Department of Energy

**REVISION TO CERTIFICATION DESIGN LETTER FOR AREA 1, PHASE II - SECTOR 1, 2a,
AND CONVEYANCE DITCH**

**Reference: Letter DOE-0297-98, Reising to Saric and Schneider, "Revision to Area 1
Phase II, Sector 1 Certification Design Letter," dated December 23, 1997.**

FINAL SAMPLE LOCATIONS

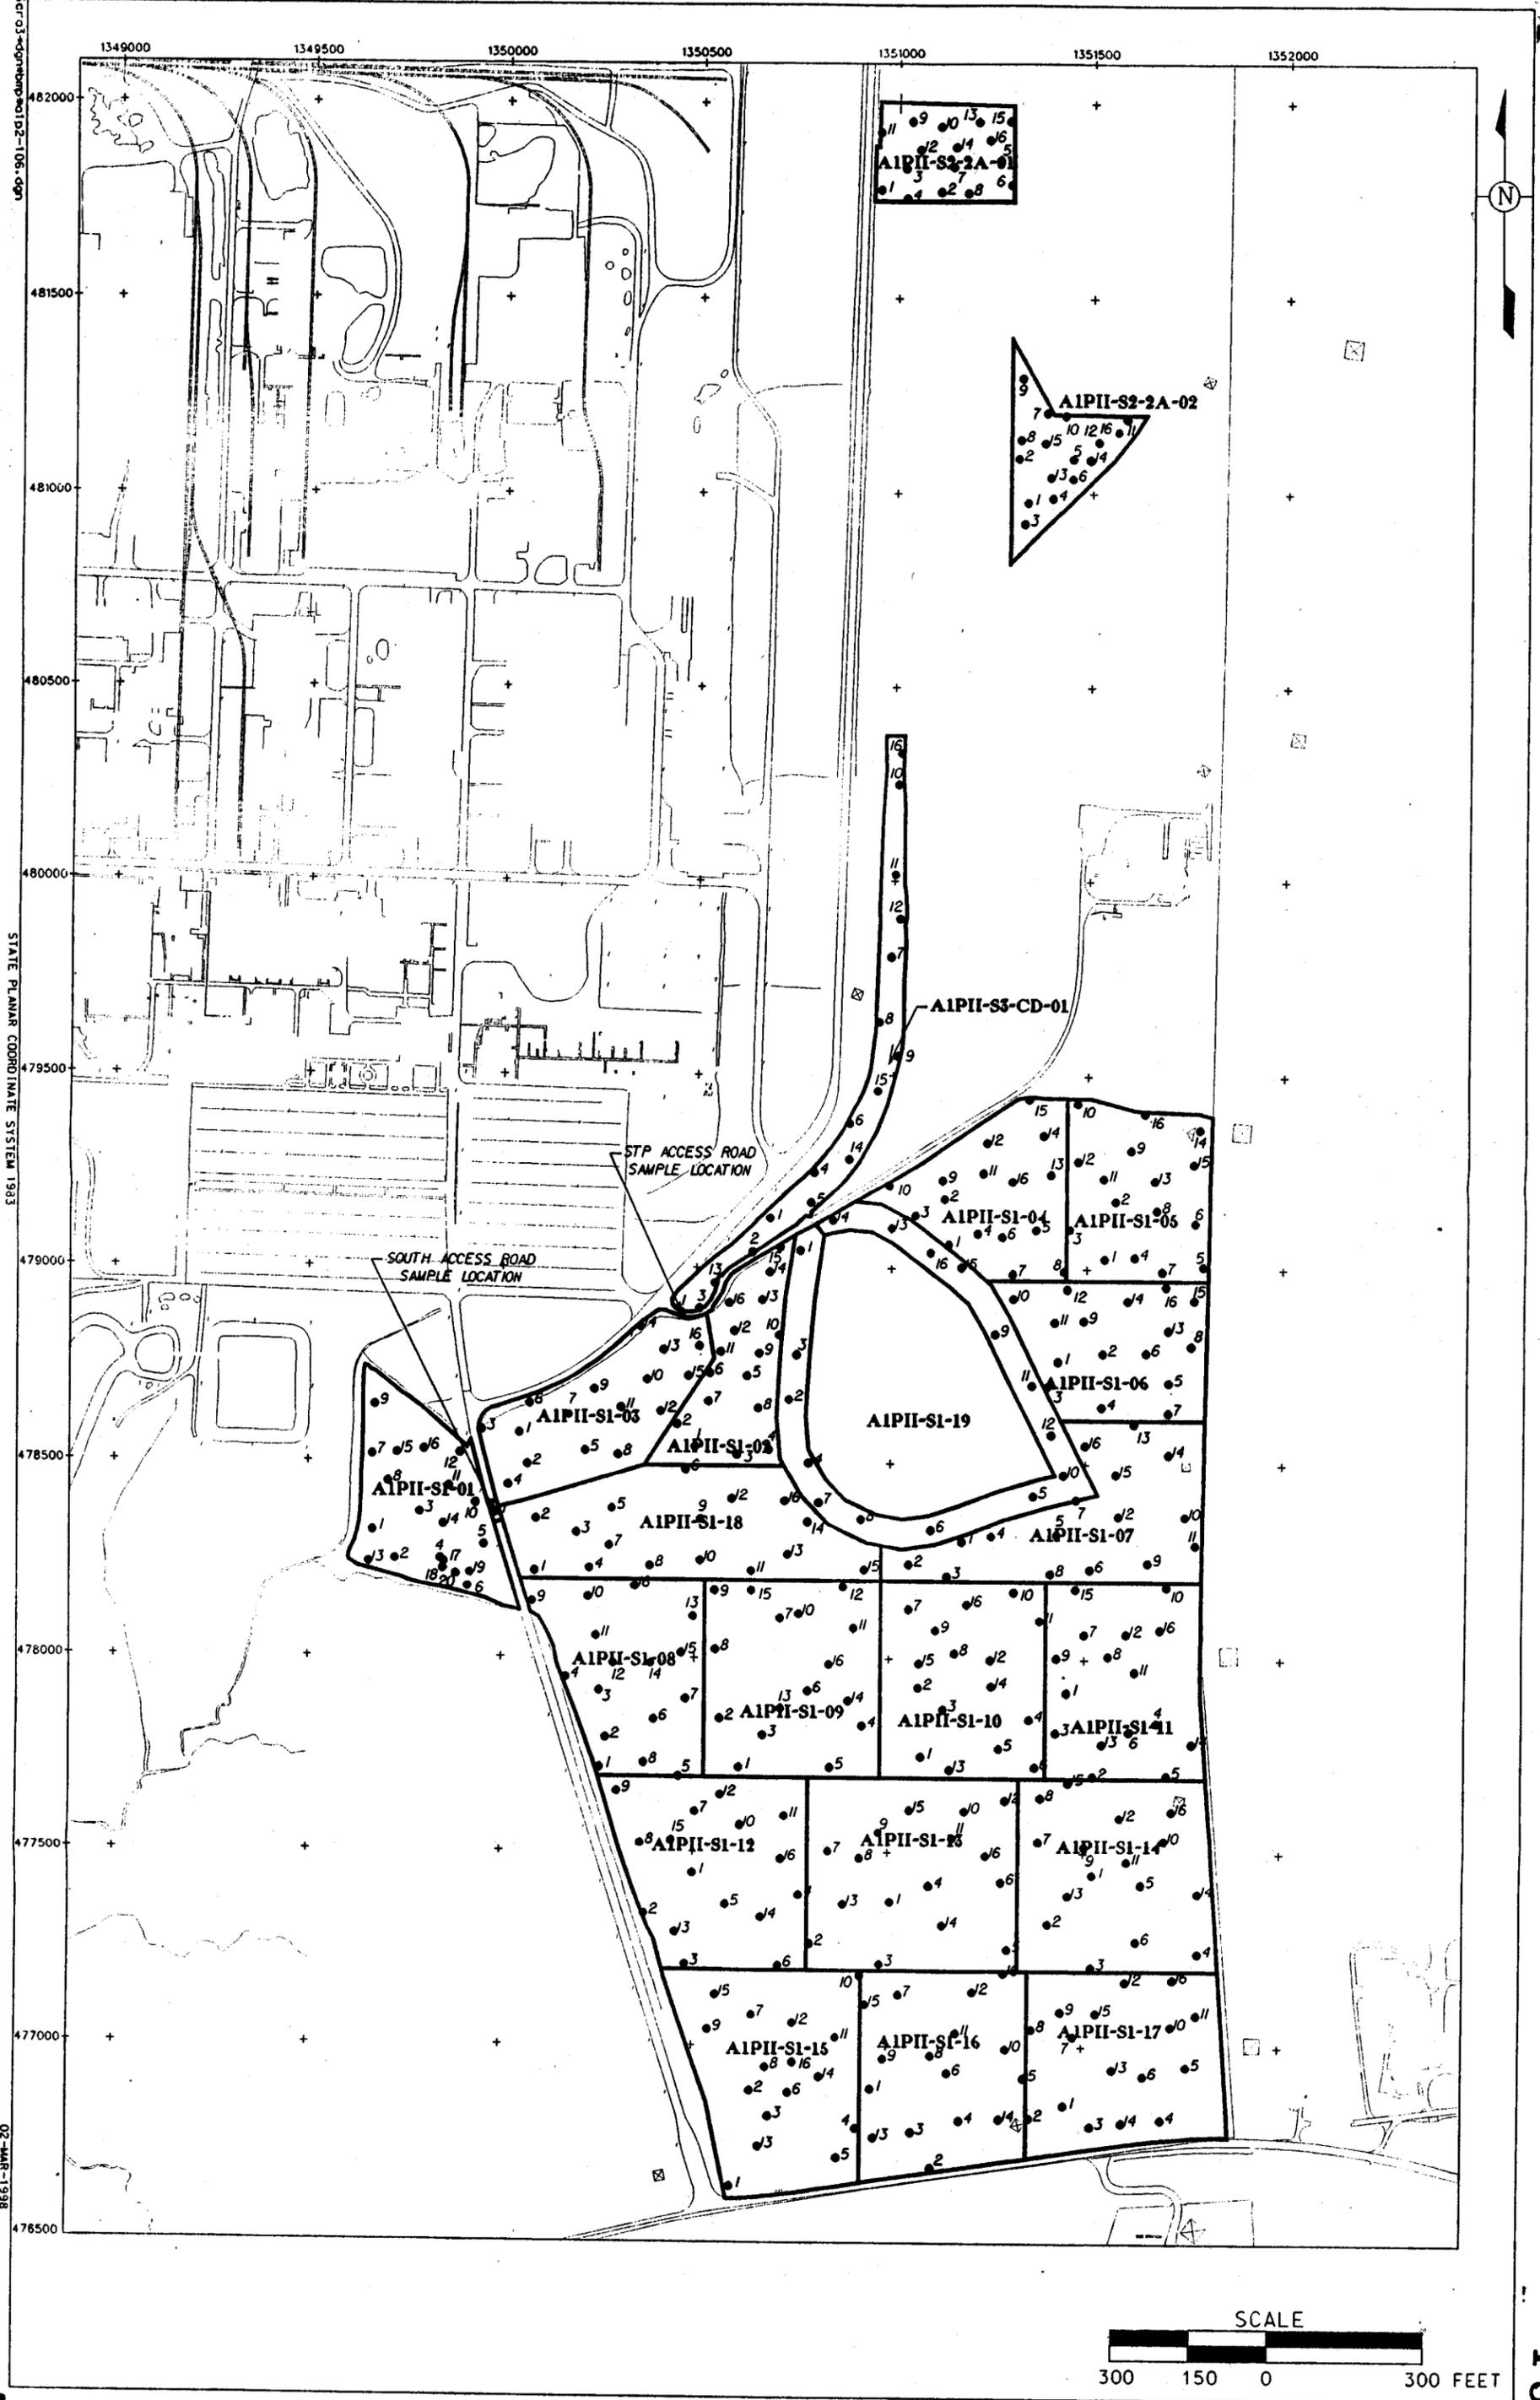
1. All comments as noted in the OEPA Conditional Approval Letter, dated January 7, 1998, have been incorporated. These include:
 - Reconfiguration of the Certification Units (CU) S1-01 through S1-08.

- The collection and analysis of 16 samples versus 12 for CUs within the initial borrow area.
2. As discussed in the CDL, the most northern CU (A1PII-S2-2a-01) falls within the footprint of On-Site Disposal Facility (OSDF) Cell 3. Also, part of the A1PI East Stockpile fell within the CU. The original plan was to move the stockpile out of the CU, and then excavate six inches from this CU. Based on field conditions, the stockpile could not be moved as far south as originally planned, but could be moved far enough to give OSDF sufficient area to construct Cell 3. Therefore, the southern CU boundary was moved approximately 50 feet north, which made the CU smaller. The random sample point selection process was revised based on the new configuration. Upon completion of the excavation of approximately six inches of material, certification samples were collected. Prior to the excavation of the area, a Radiation Tracking System (RTRAK) scan was performed and a physical sample for Waste Acceptance Criteria (WAC) determination was taken. Both the WAC sample and the RTRAK scan showed no contamination approaching the WAC or Final Remediation Level (FRL) limits. The excavated soil was then placed on the A1PI East Impacted Stockpile.

4. The sampling strategy for the CU, which represents the outfall area (A1PII-S2-01) west of the South Access Road, was modified. This area is currently being used by the South Plume Optimization Project for the installation of two force mains. Where these force mains cross the future A1PII outfall ditch, the trench excavation was not backfilled with soil (except covering the force mains) with the balance of excavated soil stockpiled within the confines of the CU. Four samples were taken from the stockpile, bringing the total number of samples in the CU to 20. The four samples from the soil stockpile will be statistically evaluated separately from the 16 CU samples to ensure that both sets of data passes CU certification, which in this case is for Characterization for Re-use.

1. Revision 2 of the PSP documented adding HPGe measurements co-located with the physical samples for the following CUs: A1PII-S2-2A-01, A1PII-S2-2A-02, A1PII-S1-04, A1PII-S1-06, A1PII-S1-18 A1PII-S2-08, A1PII-S1-10, A1PII-S1-14. This was done to collect additional data for the HPGe Comparability Study. Review of approximately 90 percent of the measurements show no contamination approaching the FRLs for Total U, Ra-226, or Thorium-232.
2. In CU A1PII-S1-05, Sample Point No. 5 was moved about eight feet to the west of its current location. The original point fell in the middle of a gravel road (1-1.5 feet thick) that was installed in 1993.
3. In CU A1PII-S2-2a-02, four sample points (Nos. 4, 6, 14, and 15) fell on the berm of the relocated North Access Road. The samplers were allowed to move the samples approximately 10 to 15 feet west to a location off the berm.

The enclosed figure shows the final configuration of the CUs and sample locations. If you have any questions, please contact Robert Janke at (513) 648-3124.
